**TOWN OF NEWBURGH
PLANNING BOARD
TECHNICAL REVIEW COMMENTS**

PROJECT: MCDONALD'S
PROJECT NO.: 2017-14
PROJECT LOCATION: SECTION 60, BLOCK 3, LOT 41.21
REVIEW DATE: 09 AUGUST 2017
MEETING DATE: 17 AUGUST 2017
PROJECT REPRESENTATIVE: CORES STATES GROUP/ ALAN D. ROSCOE, P.E.

PRELIMINARY SITE PLAN FOR MCDONALD'S SIDE BY SIDE

SHEET NO.	TITLE	DATE	REV	DATE	DESCRIPTION	BY
C1	SITE PLAN	JUL 27 2017				
	COVER SHEET

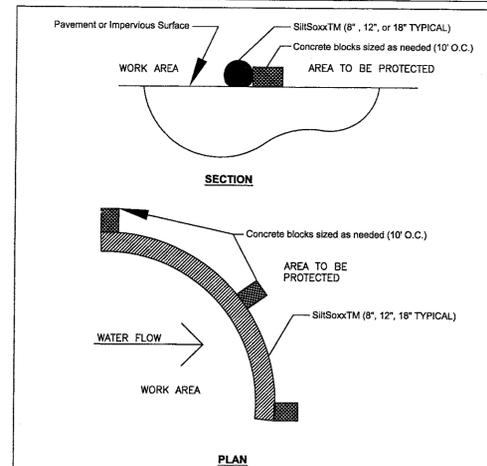
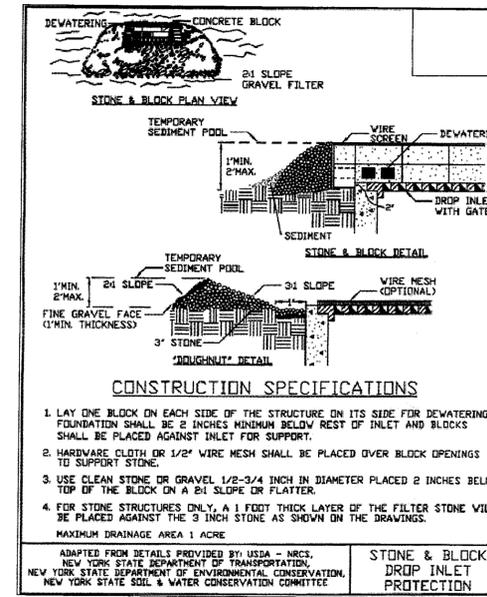
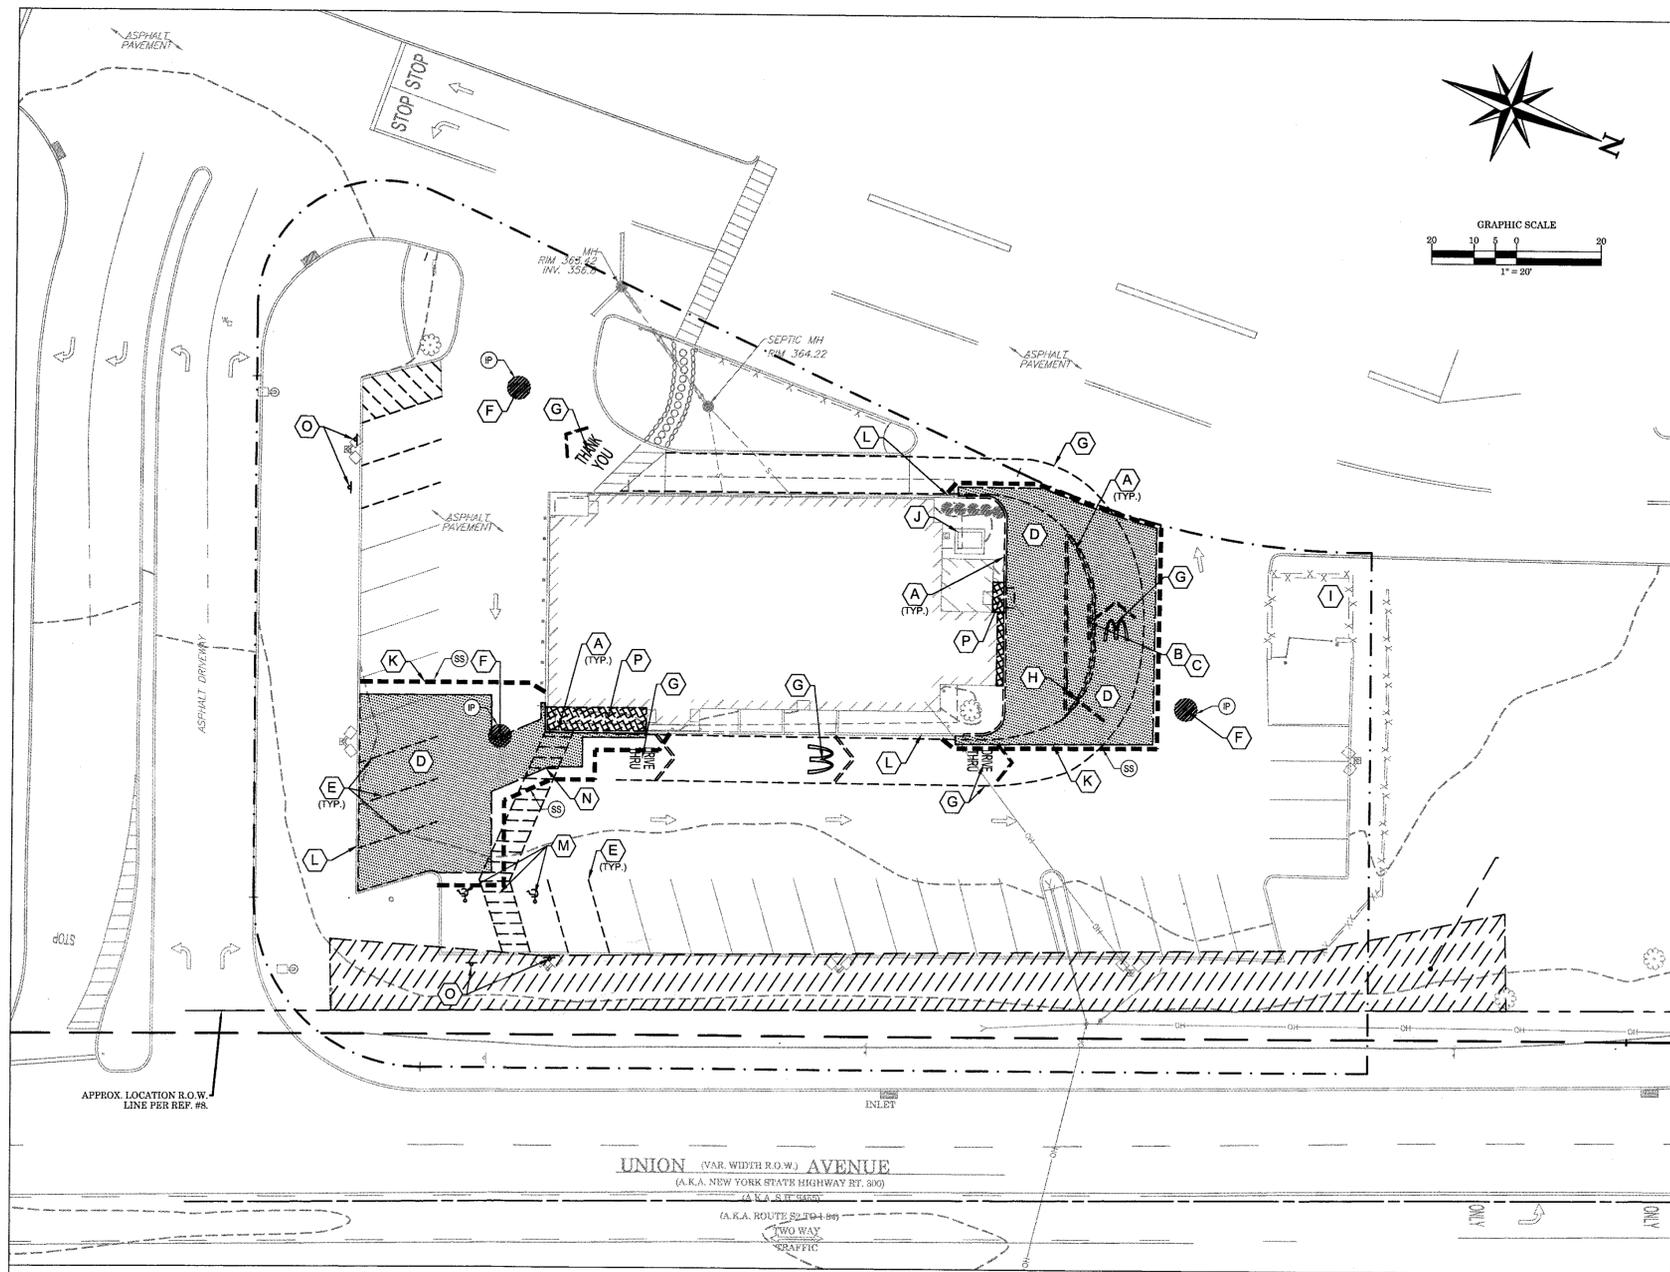
1. A demolition permit is required. Notes on sheet one should identify that a permit is required prior to any demolition.
2. General notes on sheet C4 should be revised identifying the project in the Town of Newburgh not the City of Newburgh.

PAVEMENT MARKING
Not To Scale

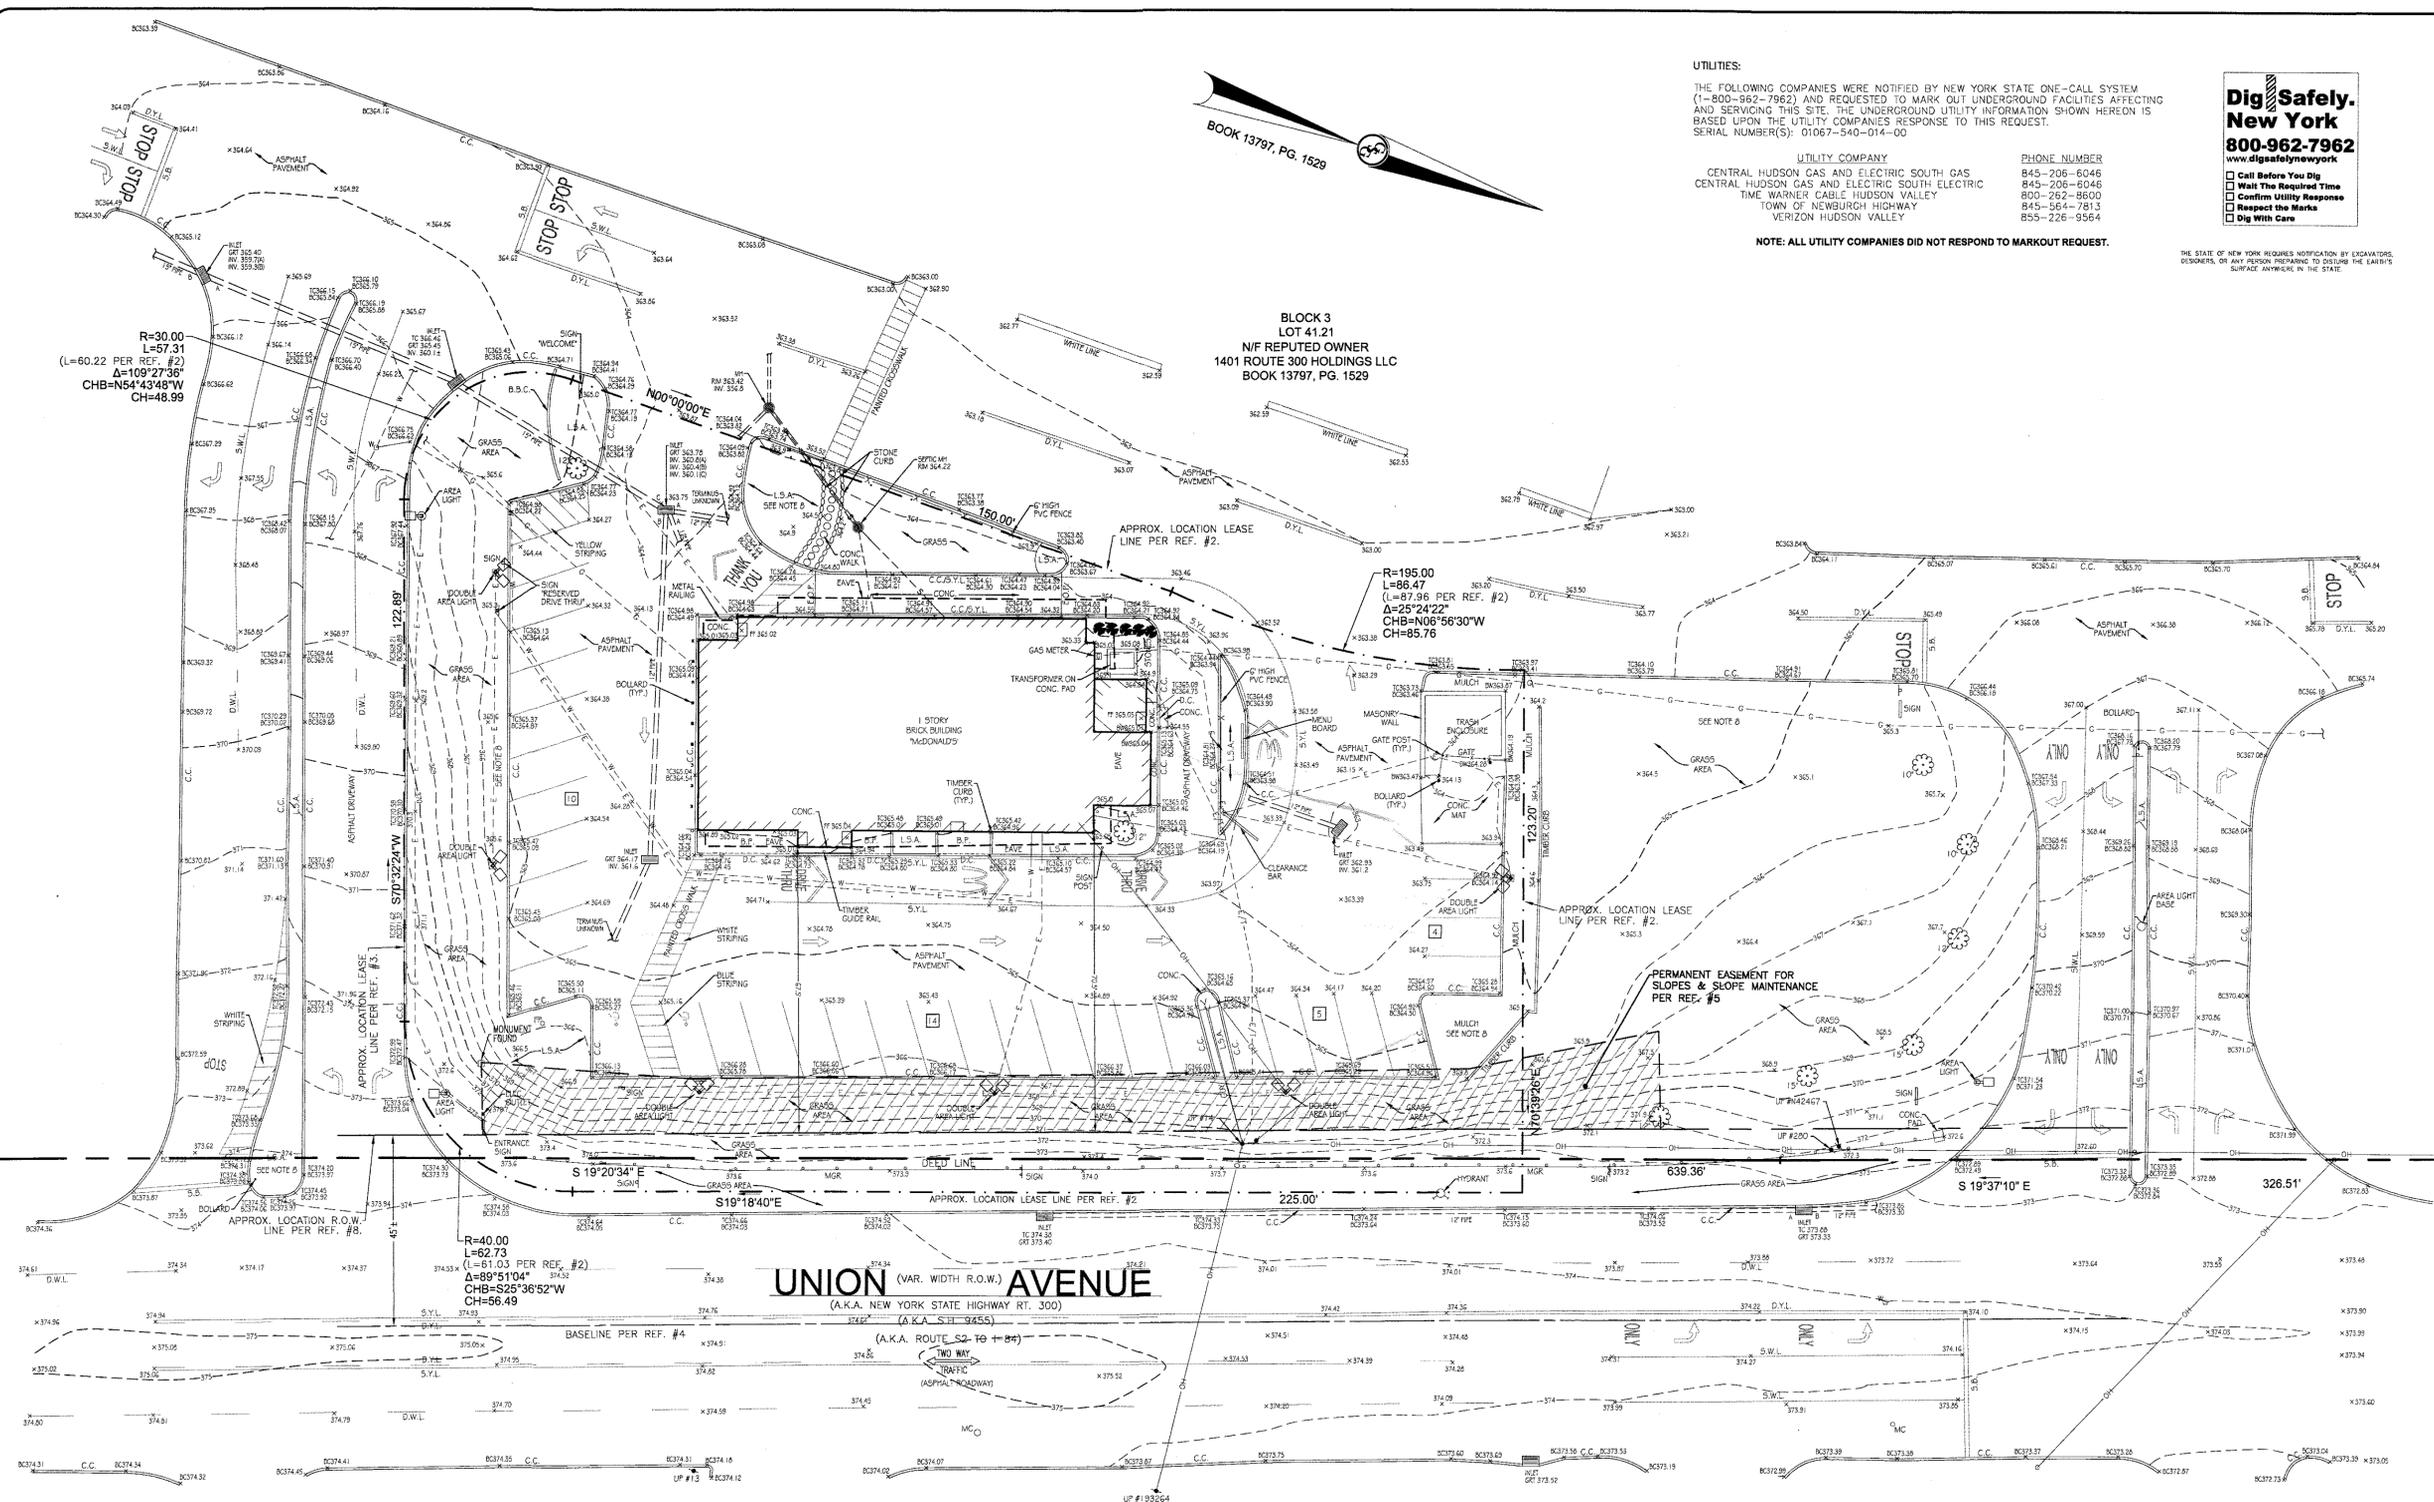
5. Parking lot striping should be in compliance with Town of Newburgh double striped lines. Detail of parking lot striping should be added to the plans. If all other existing parking spaces are to remain, parking striping should remain consistent with existing.
